ECE/TRANS/WP.29/GRSP/2006/5
3 March 2006

PROPOSAL FOR DRAFT AMENDMENTS TO REGULATION No. 29

(Cabs of commercial vehicles)

Transmitted by the expert from the Russian Federation

Figure 1: Front part strength testing (Test A)

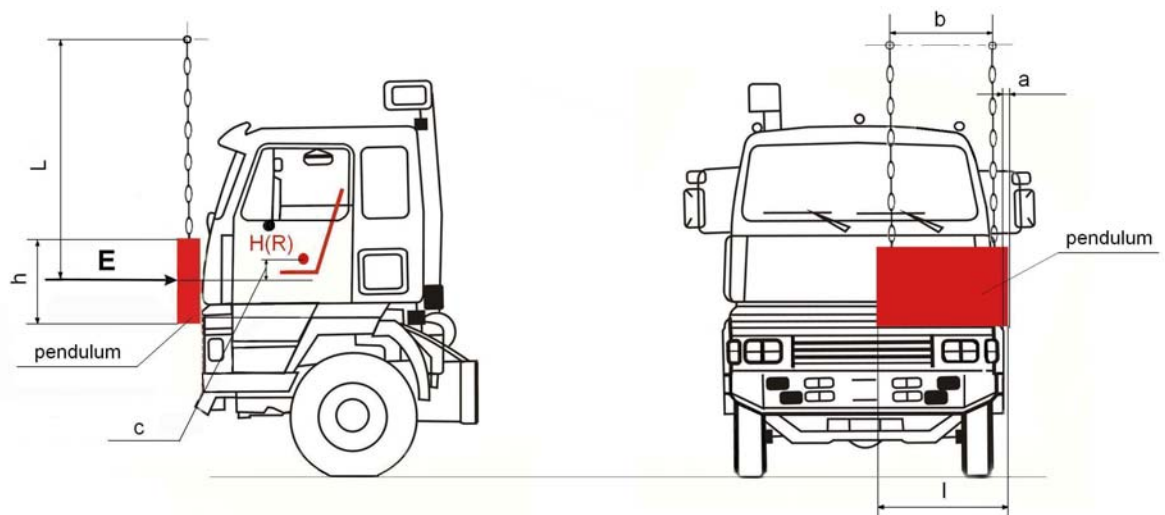
- 4.2.1. The swing-bob must strike the cabin while moving from front to back. The strike direction must be horizontal and parallel with the middle longitudinal section of the vehicle (figure 1). The energy of the strike must be equal to 40 kJ for vehicles of category N₃, [30] kJ for vehicles of category N₂, and [25] kJ for vehicles of category N₁.
- 4.2.2. Test A may be skipped for vehicles of category N₁ if they fulfill the test requirements according to Regulations No. 94.

Figure 2: Roof strength testing (Test B)

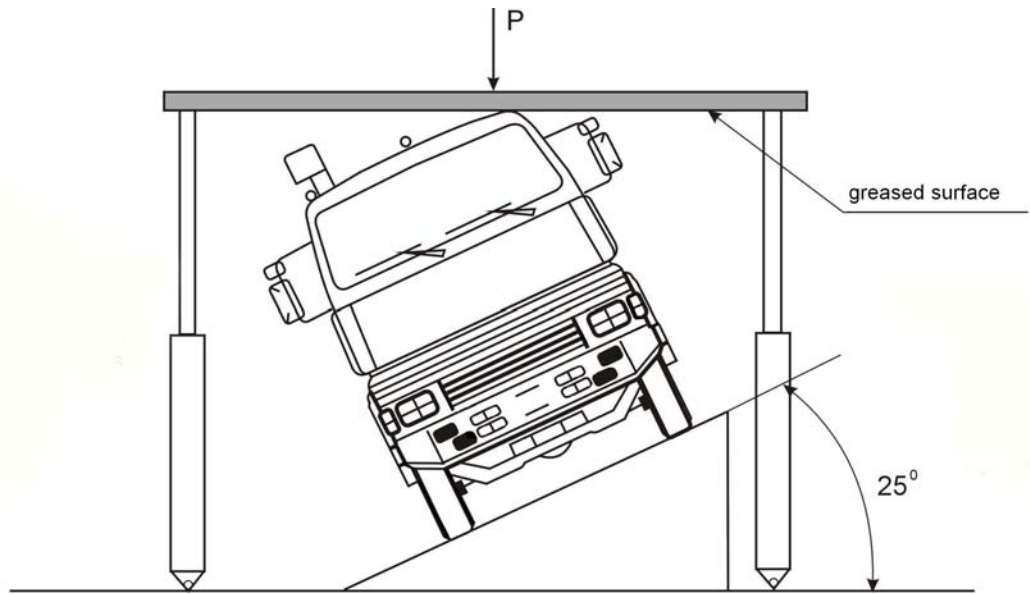
- 5.1. The driver's cab must be tilted by 25 degrees against its longitudinal axis so that the driver's side would be lifted (figure 2).
- 5.2. The load must be applied through a suitably shaped rigid plate, the down side of which is uniformly greased.
- 5.3. The driver's cabin roof must endure static load P of
$$P=[K] P_{CH}$$

Figure 3: Back part strength testing (Test C)

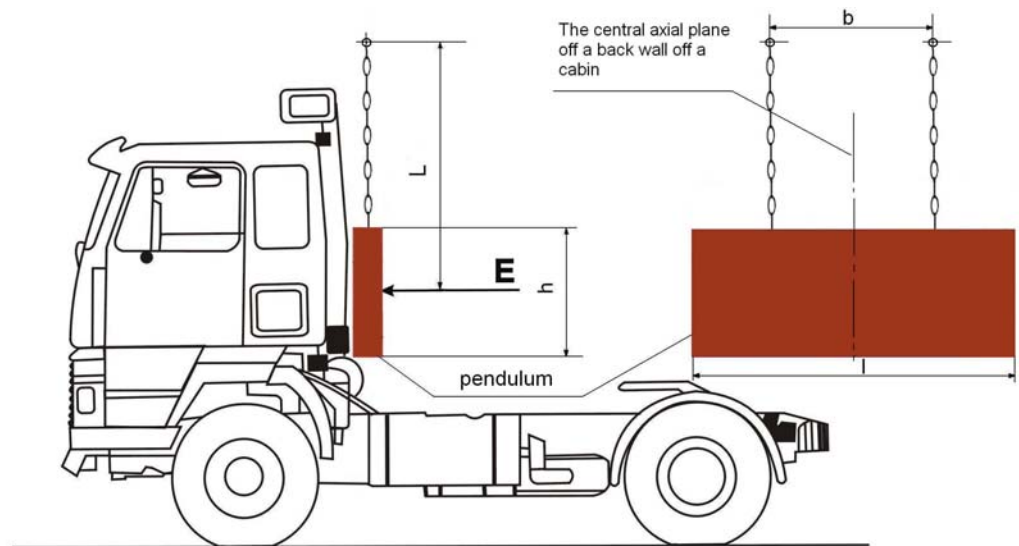
The swing-bob shall strike the driver's cab from the back and shall be directed to the front (figure 3). The strike direction shall be horizontal and parallel with the central longitudinal section plane of the vehicle. The centre of the strike shall coincide with the central axial plane of the back wall and be located in the middle point between the floor and the roof of the cabin. The energy of the strike shall be equal to 30 kJ for vehicles of category N₃, [20] kJ for vehicles of category N₂, and [15] kJ for vehicles of category N₁.
